Property Inspection Report

OPEN FRAME

Amos Benjamin Charles
5115 Marble Acres Ct.
Houston, TX 77059
Reserve at Clear Lake

Inspection Date: Tuesday, July 05, 2016
Start Time: 07:41 am **End Time:** 10:02 am
Builder: Ryland Homes
Plan: Trieste II, Elevation C, Right (or variant of)
Square Feet: 3,678 per plan / 3,400 per revisions to meet local zoning requirements
Bedrooms: 5
Bathrooms: 4

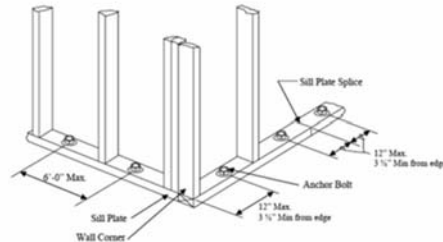
The metal firestop collar installed in the fireplace chimney chase was not installed well and will not protect against fire drafting. We recommend that this be repaired for fire safety. **REVISED:** The area which requires repair is marked on the photograph below in Red. This gap cannot be repaired using caulk or expanding foam; a hand can be placed through the gap.

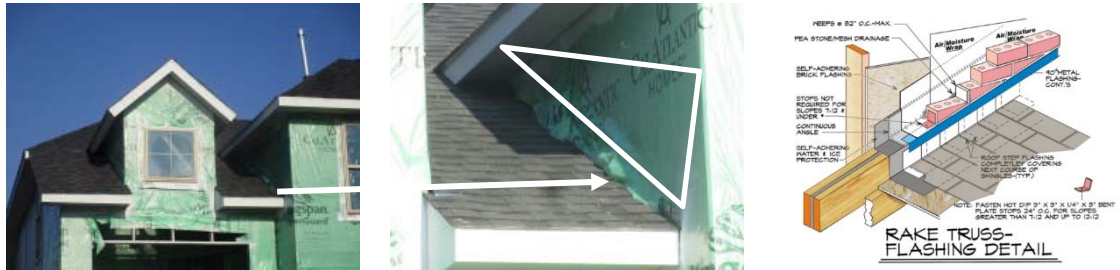
Notice: Anchors were not installed within 12 inches of a splice in the wall between the great room and master bedroom. While this would not typically be an issue at an inside wall, this wall appeared to be designed and installed as a shear wall. We recommend that the design engineer approve the installation or stipulate repairs.
